NEW
RIVER

Burgess Hill

Design & Access Addendum

Proposed Section 73 Amendments

4.6 Retail Conversion - Unit 01 Elevations

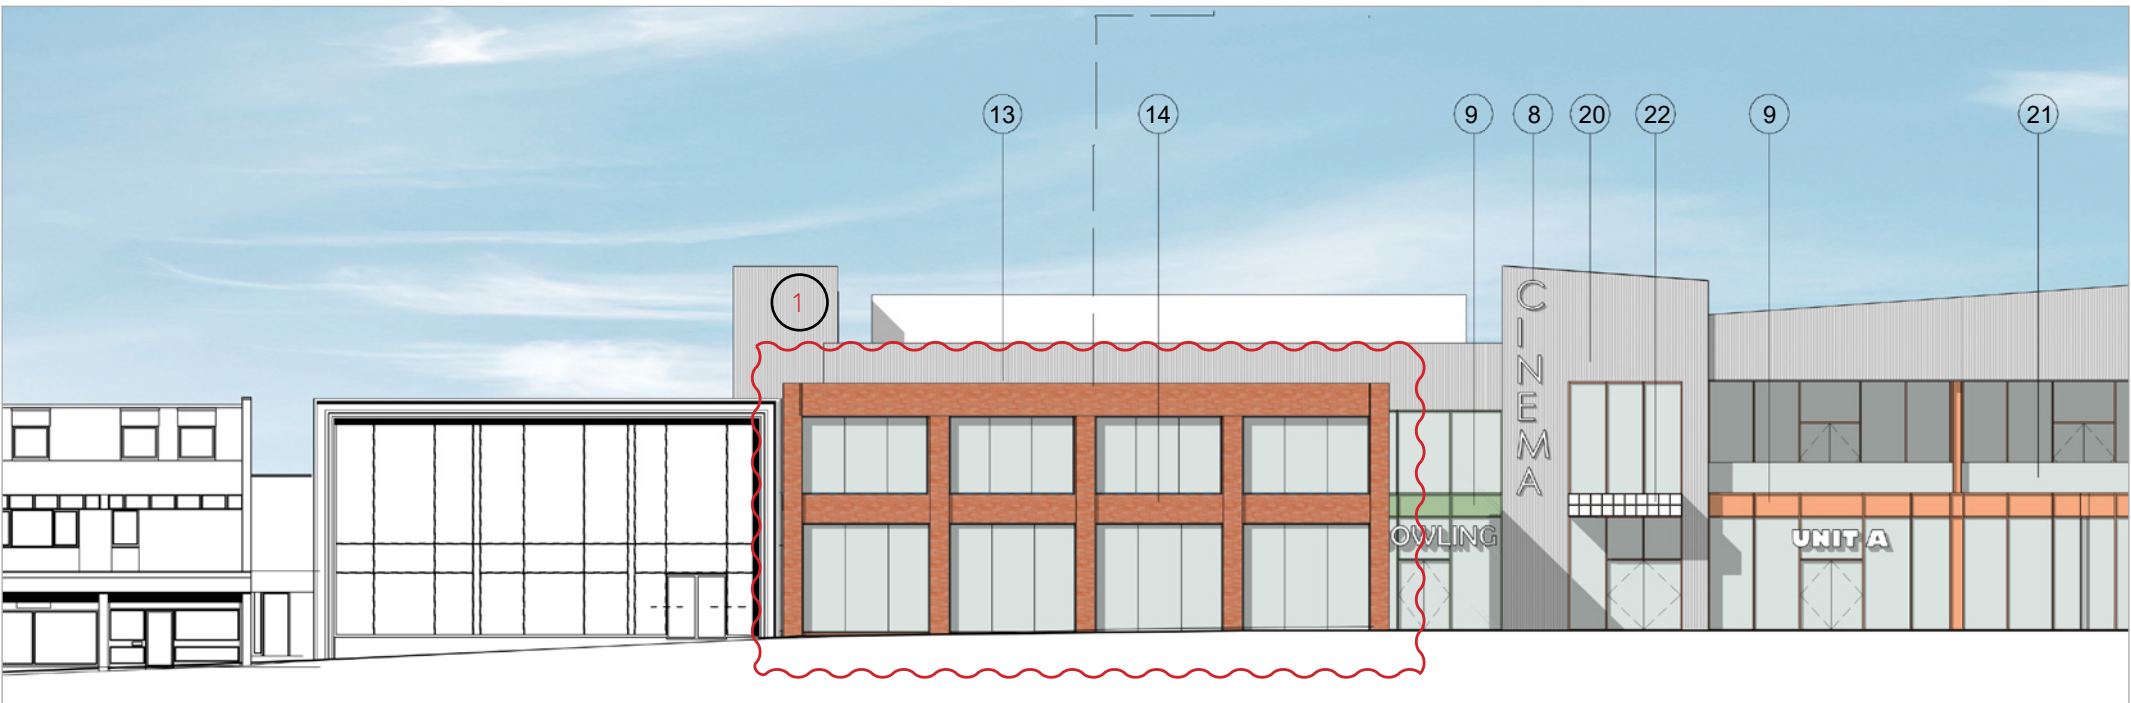
- 1. The consented scheme included for a new shop front on the North Western elevation adjacent to the recently completed Library. The elevational treatment included a fully glazed shopfront at ground level, aluminium framed window and dark grey stone effect cladding at first floor level and a stone effect frame to the whole façade. This language united the shop front with the new cinema block as well as the shopfront of the new food store opposite. The revised proposal includes for the necessary demolition and refurbishment works to provide new shop fronts to both the North Western and South Western elevations. With the above outlined changes to the units site positioning and connection of the ground and first floor units the façade language has been informed by the new shopfronts to the other retail units along Church Walk (Block A2). Red brick piers with stone capping details form bays to break the shop frontage vertically, and new floor to ceiling glazing is provided at ground and first floor.

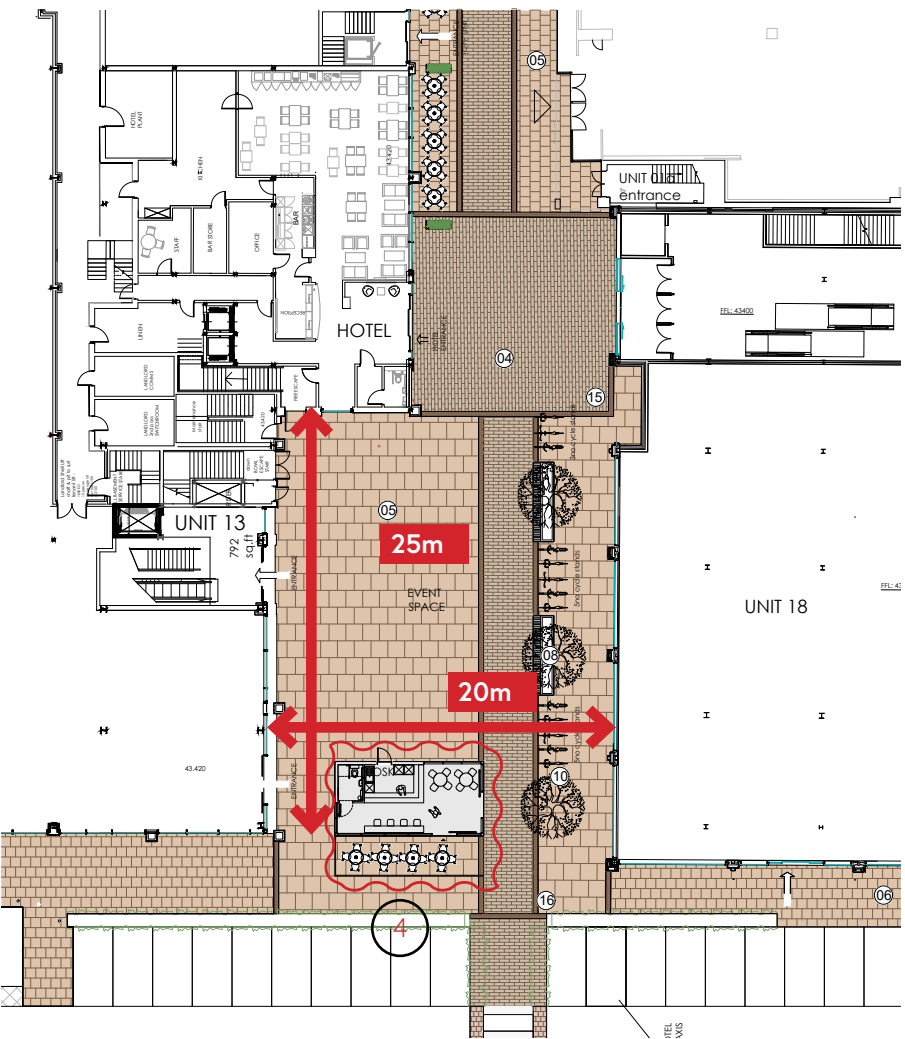
- 1. In the consented scheme the new square, noted as Event Space on the approved plans, was a widened portion of Church Walk to the South western end of the retail arcade as adjoining the car parking zone. This public square was 20m wide and 25m deep. In the revised proposal the reduction of the leisure block (Block B2) facilitates the widening of this area creating a more meaningful public square, now called The Common. The Common is 63m wide and 45m deep.

- 2. The public square of the current scheme is enclosed by entrances to the hotel, bowling alley, maintenance stair, retail uses and the entrance to the cinema. In the revised scheme there is increased frontage onto the public realm, providing greater activation to this vital space. The Bowling alley, Cinema, Gym, retail spaces, food store, hotel and food & beverage are all access to/from the common.

- 3. In the consented scheme the new square was hard landscaped with a variety of large and small paving in warm buff zones. By contrast the increased scale of the common facilitates a wide variety of space, with a mixture of hard and soft landscaping, and notably enhanced greening of the public realm of Burgess Hill. The landscaping strategy incorporates play spaces, seating areas, flexible event zones and lounging lawns amongst dense planting, trees and informally planted edges.

- 4. In the consented application a glazed kiosk building is located on the south western edge of the square. This is omitted in the S73 application in favour of the above listed variety of spaces created within the landscape.

5.5 The Lanes

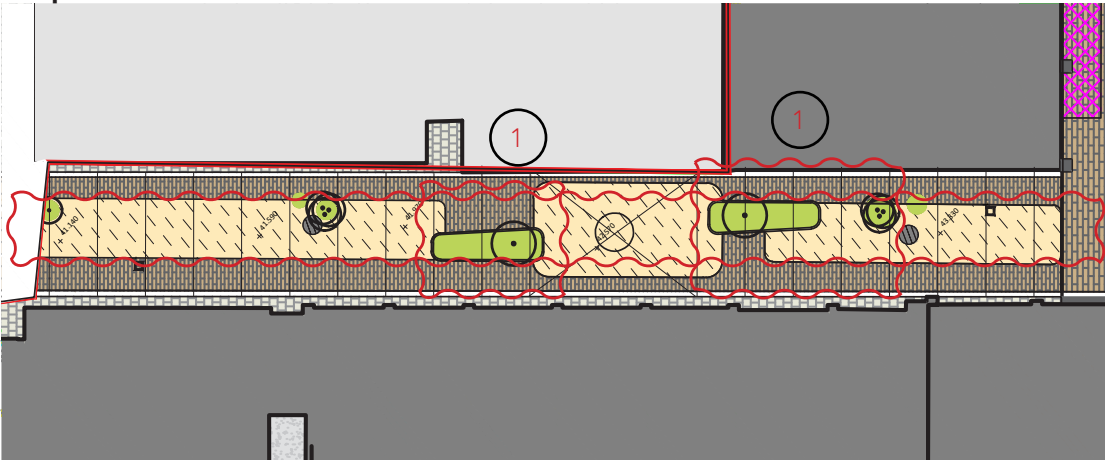
- 1. In the consented application the retail street connecting the public square and Church Walk is hard landscaped in the same warm buff paving. The revised application introduces soft landscaping by way of small pockets of greenery and trees to break down the space.
- 2. The revised proposal develops this area of Church Walk, between the Common & The Bandstand into a dynamic passage. A creative floorspace, drawing on local materials, patterns and vernacular references is applied underfoot, whilst overhead lighting creates a more intimate scale. All of the interventions are designed to complement the active frontages of the local retail units.

5.6 The Corner - Use & Character

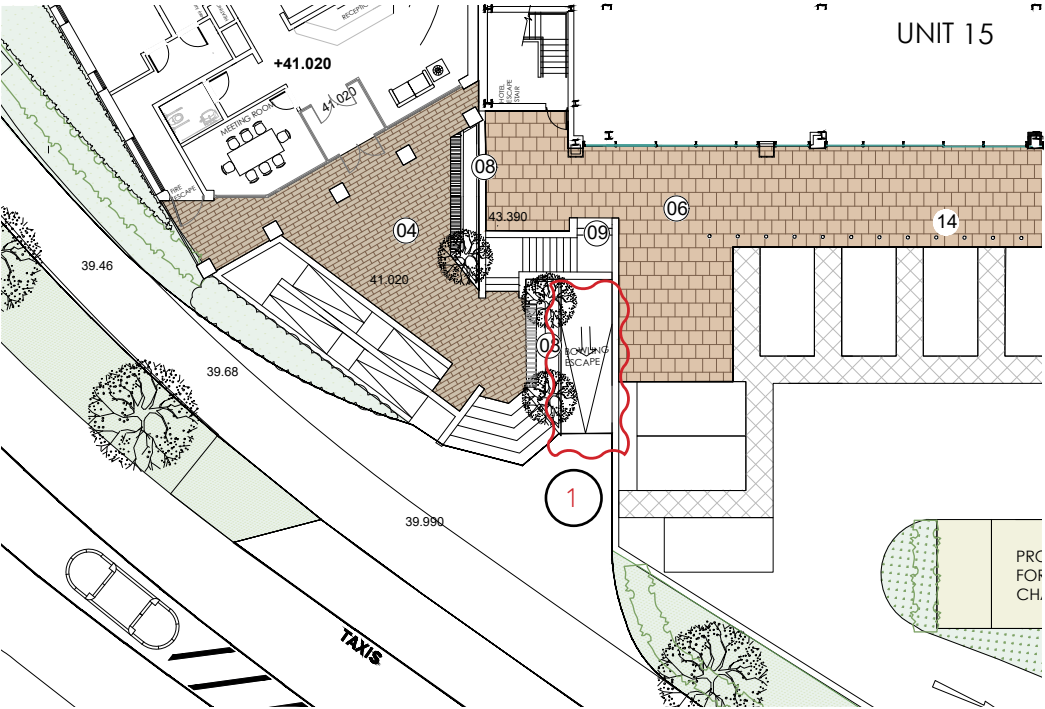
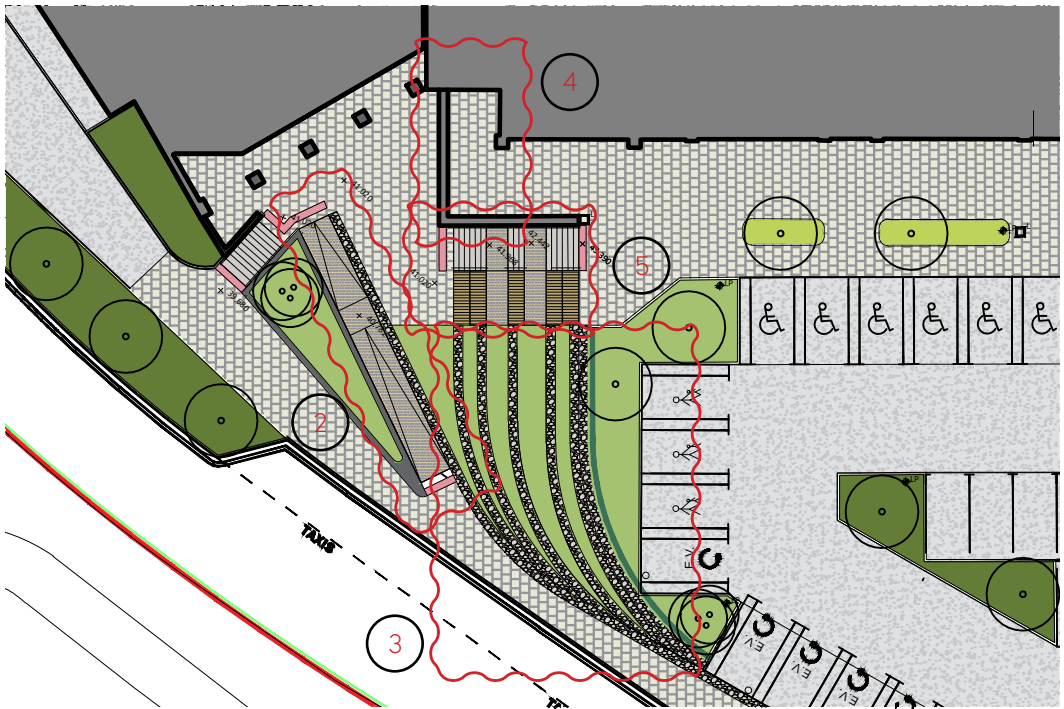
1. The junction between the main entrance to the residential block (Block A1) and the south western corner of the car park covers a fairly significant level change. The consented application also had an exit route from the basement bowling alley below the landscaping, which discharged onto Civic Way. With the relocation of the Bowling Alley into Block B and omission of basement conversion this exit point is no longer required in the revised application.

2. The consented application included a dog legged ramp to provide an accessible route from Civic Way to the ground floor level of the residential block. With the omission of the bowling alley access route the ramp is revised to a straight run that works with the natural topography of the site.

3. Gabion steps, planted at each level with wildflowers, replace the vertical retaining wall adjacent to the car park. Sweeping around the corner this landscaping intervention significantly softens the edges of the scheme and greens the boundary of the Car Park and Civic Way.

4. In the proposed updated scheme, the retaining wall between the Hotel escape stair (adjacent to the food store shop front) and the residential entrance has been pulled back away from the residential entrance to provide more breathing space to the ground floor lobby of Block A1 and ensure improve the security of the balcony on the first floor adjacent to the hotel escape.

5. In the consented scheme an S-shaped external staircase connected the residential ground floor level directly to the main external car park and public realm level. In the revised scheme this stair is adjusted to a straight run with improved destination visibility. The staircase also incorporates public seating, optimising the south facing orientation and enhance the landscaping offering for both the public and residents.

5.7 Car Park

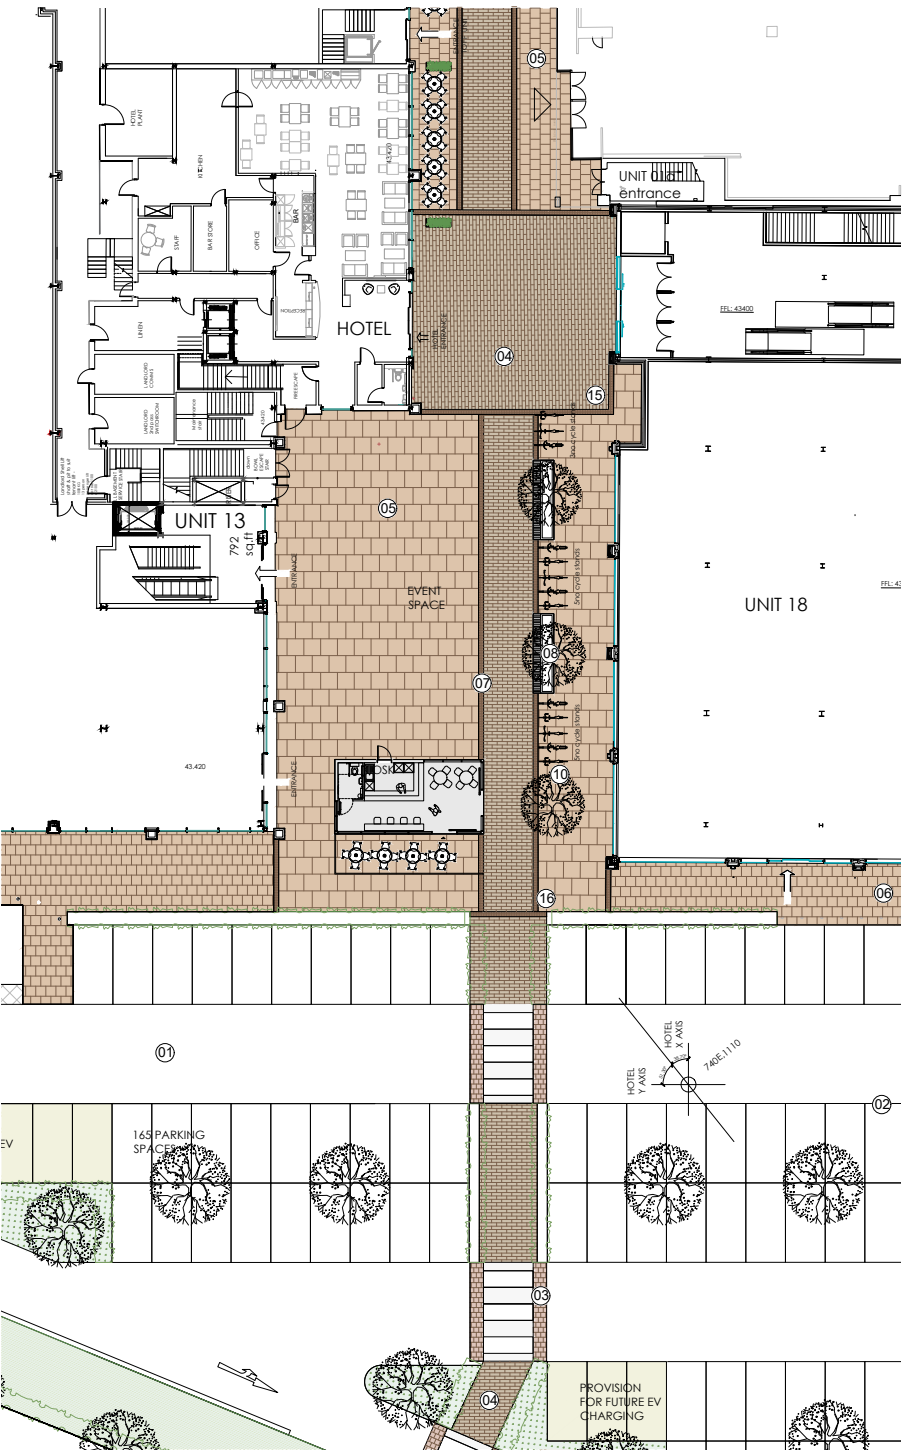
- 1. In the consented planning application the Civic Way Car Park provided 171 spaces, created by way of an extension to the existing Martlets Car Park. This revised proposal seeks to increase the parking provision in the Civic Way Car Park to 197 spaces. The 26 additional spaces will be allocated to residents of Block A1, these spaces account for those no longer allocated in the lower ground of Block A1. The total number of parking spaces across the whole scheme remains unchanged as 242 spaces.

- 2. In the consented application the Civic Way parking followed the same South Western boundary as the existing neighbouring parking, remaining south of the public square. In the revised proposal 17 spaces are integrated into the landscape of the public realm, extending the parking northwards into the Common. These spaces are will be softer, through the use of grasscrete and soft planted edge, forming a transition to the rest of the common. This area of parking is flexible and could also be used to host events like farmer's markets, outdoor cinema screenings or gym classes as the town centre of Burgess Hill evolves.

5.8 Cycle Hub

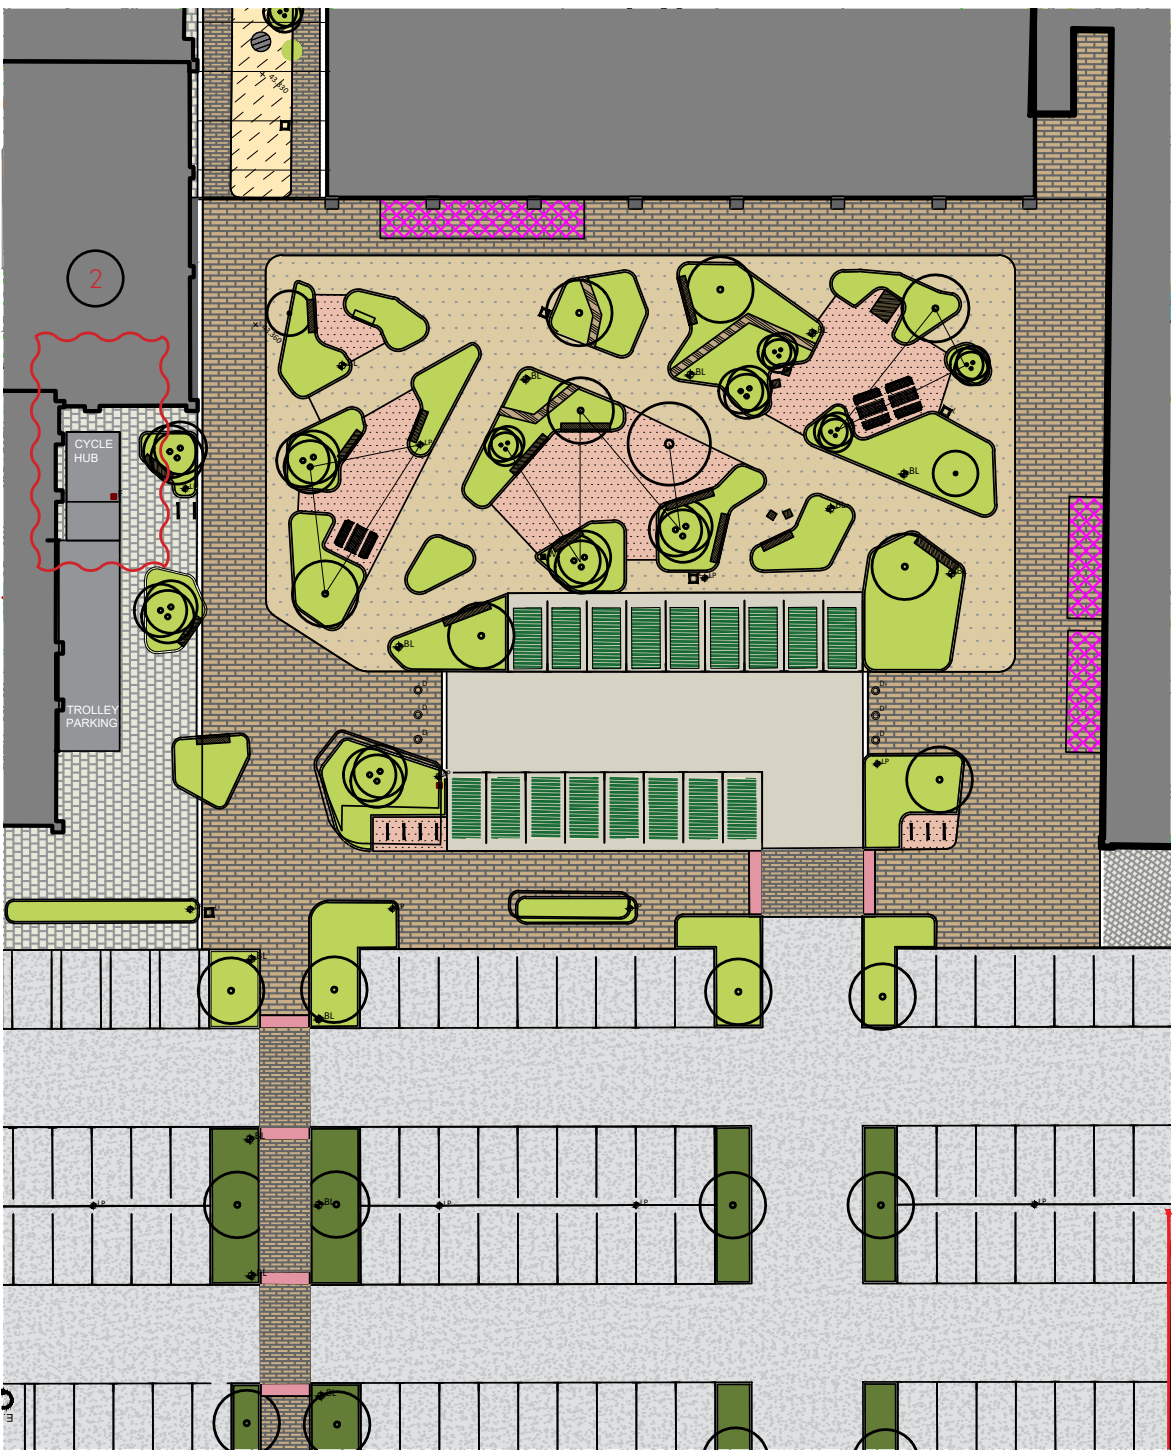
- 1. The consented application included public bicycle stands on the public square outside of the south western boundary of Block B. The revised application proposes relocating the Sheffield stands to various locations with the public realm with key consideration to the cycle networks.
- 2. Following matters raised in the West Sussex County Council Consultation regarding highways, a letter dated 22.04.2020 was submitted by WSP on behalf of our client New River REIR (UK) Limited committing to the delivery of a new Cycle Hub. As part of this revised submission a Cycle Hub is now proposed on the north western end of Church Walk where there is an existing planter bed. The cycle hub will connect to the proposed cycleway enhancements as part of a gateway entry to the Town Centre.
